HISTORIC AND DESIGN REVIEW COMMISSION

HDRC CASE NO: 2024-082
ADDRESS: 445 DEVINE ST
LEGAL DESCRIPTION: NCB 2957 BLK 1 LOT 12
ZONING: R-5, H
CITY COUNCIL DIST.: 1
DISTRICT: Lavaca Historic District
APPLICANT: Camden Greenlee/GREENLEE CAMDEN & TINA
OWNER: Camden Greenlee/GREENLEE CAMDEN & TINA
TYPE OF WORK: Construction of a rear accessory structure
APPLICATION RECEIVED: February 14, 2024
60-DAY REVIEW: April 14, 2024
CASE MANAGER: Edward Hall

REQUEST:

A001
SITE PLAN

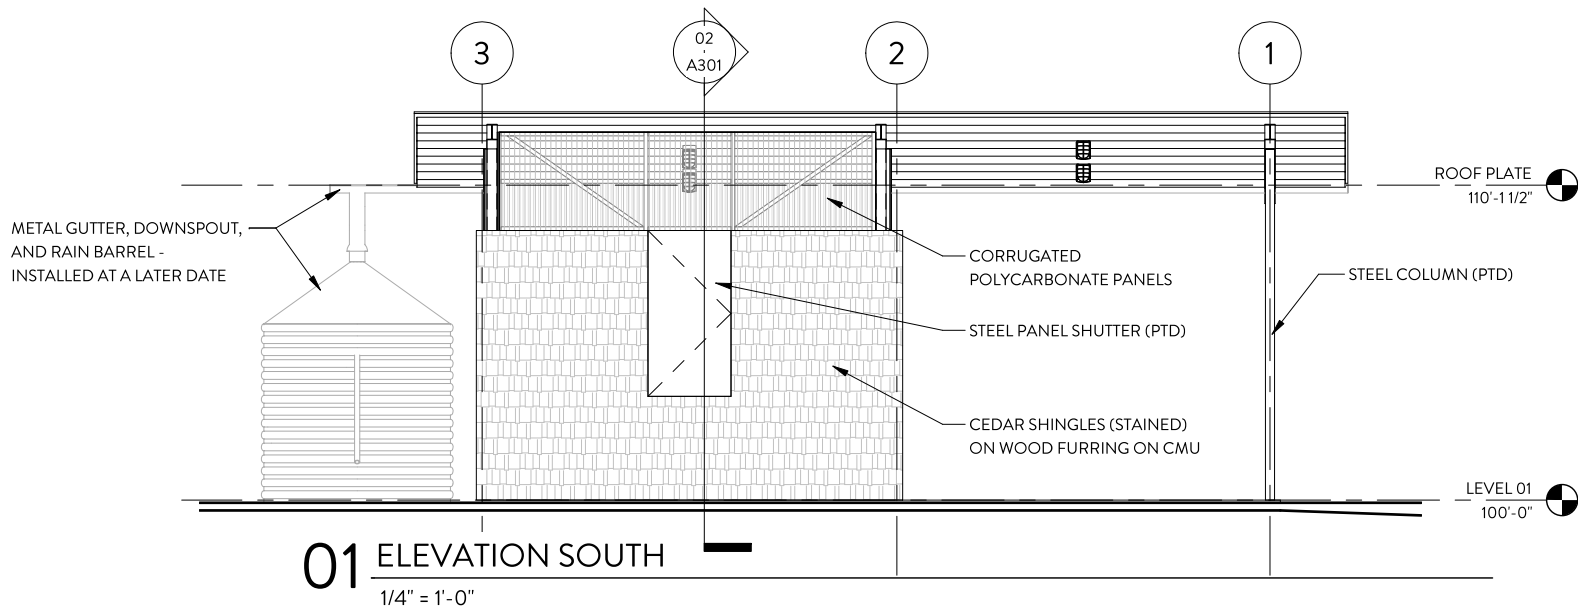
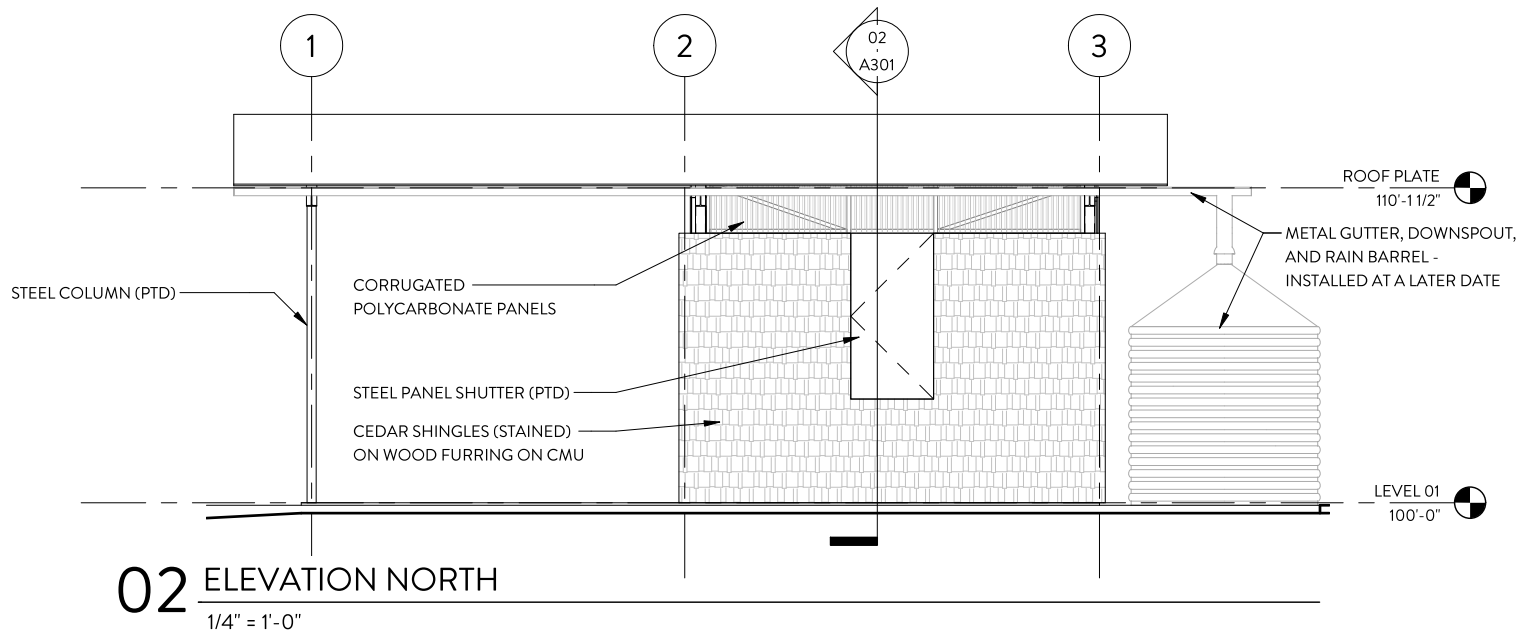
- e. ORIENTATION & SETBACKS (Rear Accessory) – The Guidelines for New Construction 5.B. notes that the predominant accessory structure orientation and historic setback patterns of the block should be followed. Generally, staff finds the proposed location, orientation and setbacks associated with the proposed accessory structure to be appropriate and consistent with the Guidelines.

A201
EXTERIOR
ELEVATIONS

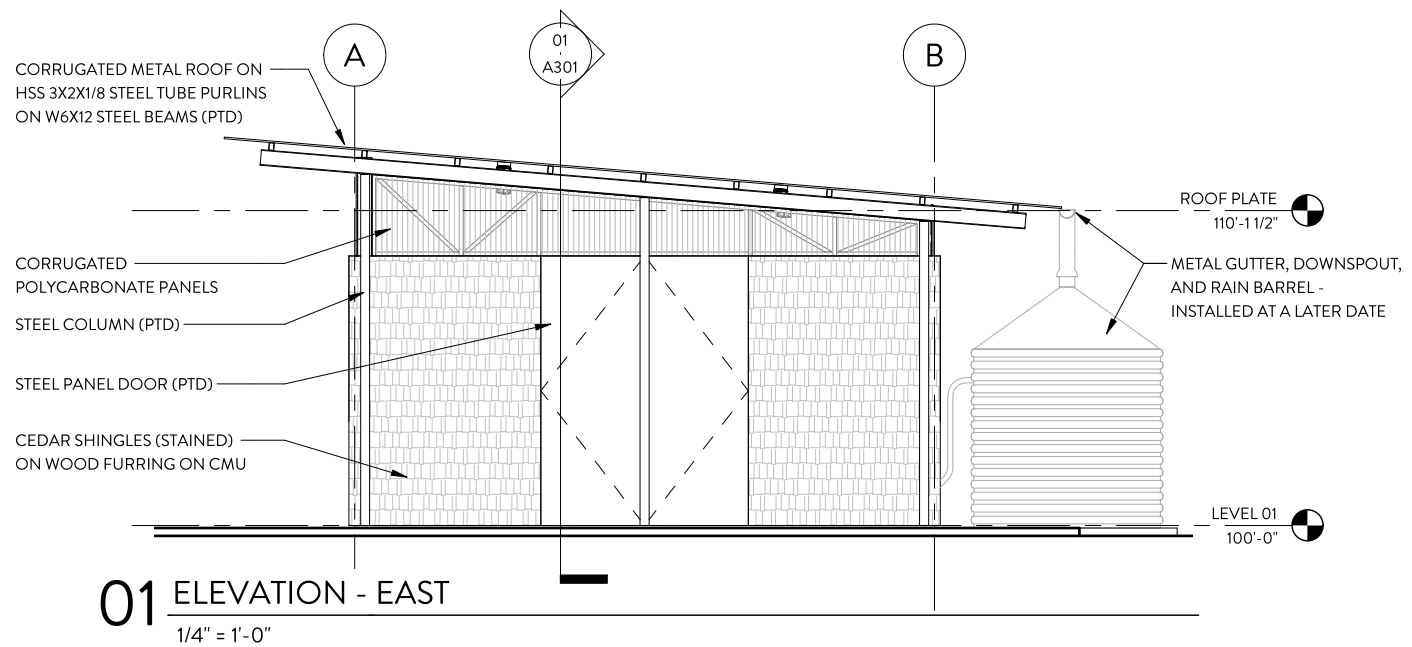
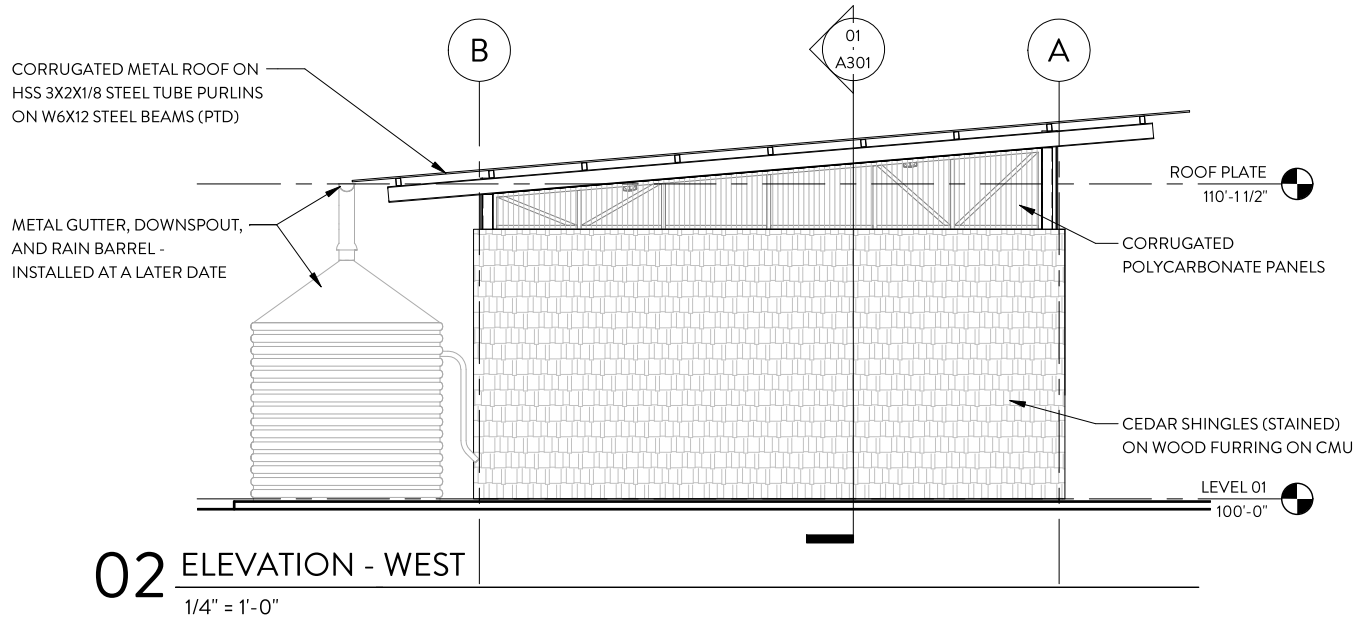
- f. MATERIALS (Rear Accessory) – The applicant has proposed for materials to feature cedar shingle siding, corrugated polycarbonate panels, steel shutters, steel columns, and a corrugated metal roof. The Guidelines for New Construction 5.A.i. notes that new garages and outbuildings should relate to the period of construction of the primary structure on site through the use of complementary materials and simplified architectural details. The primary historic structure on site features wood siding and trim installed in a traditional manner. Materials such as the proposed corrugated polycarbonate panels, steel shutters, steel columns and corrugated metal roof are not found historically within the Lavaca Historic District in residential construction (both primary and secondary/accessory structures). Staff finds that materials that are found historically within the district should be used in the new construction in place of the proposed polycarbonate panels. Additionally, staff finds that roofing materials that are consistent with the Guidelines should be used (standing seam metal) and that the wood or wood clad columns and exposed structural elements should be incorporated into the design. Metal façade elements, such as corrugated metal panels are found on new construction that has been approved by the Commission.

- h. CHARACTER / ARCHITECTURAL DETAILS – The Guidelines for New Construction 5.A. notes that new garages and outbuildings should relate to the period of construction of the primary structure on site through the use of simplified architectural details. Additionally, the Guidelines notes that window and door openings should be designed to be similar to those found on historic accessory structures within the district or on primary historic structure on site. The applicant has proposed for the structure to feature a shed roof and windows that are generally proportioned similarly to those found within the district. Historically, accessory structures within the district feature gabled roofs. Staff finds that a gabled roof should be installed.

- i. That materials that are found historically within the district be used in the new construction in place of the proposed polycarbonate panels, such as wood siding or clerestory windows. Additionally, staff recommends that roofing materials that are consistent with the Guidelines should be used (standing seam metal) and that the wood or wood clad columns and exposed structural elements should be incorporated into the design in place of the exposed steel elements. Standing seam metal roof materials should be consistent with the following standards: panels should be 18 to 21 inches in width, seams should be 1 to 2 inches in height, panels should smooth with no corrugation or striation. 5 V-crimp roofing may also be used for an accessory structure.
- ii. That the roof form be modified from a shed profile to a gabled profile, as noted in finding i.
